City of Franklin

Meeting Agenda

Tuesday, February 11, 2025

AVALON SQUARE PUD SUBDIVISION VESTING EXTENSION REQUEST RESOLUTION 2025-05

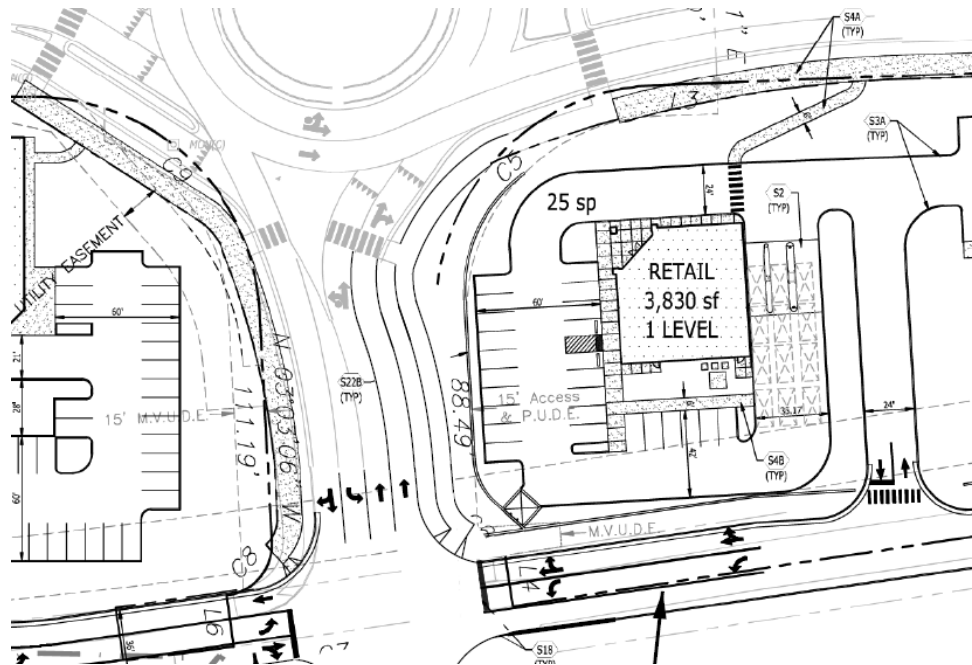
At the Site Plan stage, Applicant to shift the proposed junction box clouded below to be out of the turn lane. (C3.13). Additionally, the 54" RCP should be directed to discharge more parallel to the retaining walls adjacent to the bioretention areas instead of perpendicular, as schematically shown in the sketch above.

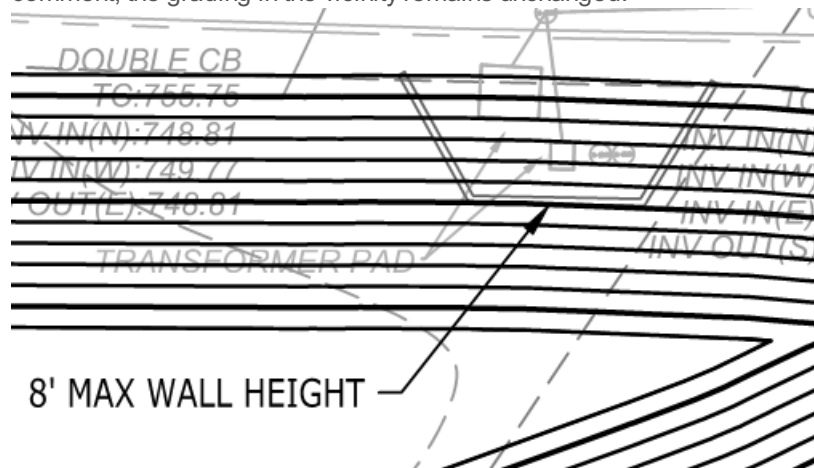
lance.fittro@franklintn.gov The previous comment has largely been addressed (thank you), but the box shown below which persists on sheet C3.18 shall be removed:

and another reference to TSS removal requirements remains in the narrative on sheet C3.01:

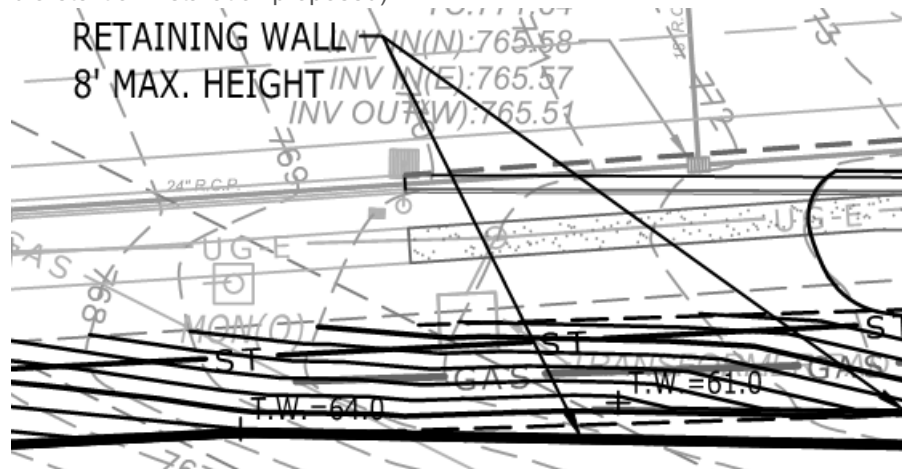
While a wall has been added around the transformer pad to address the previous comment, the grading in the vicinity remains unchanged:
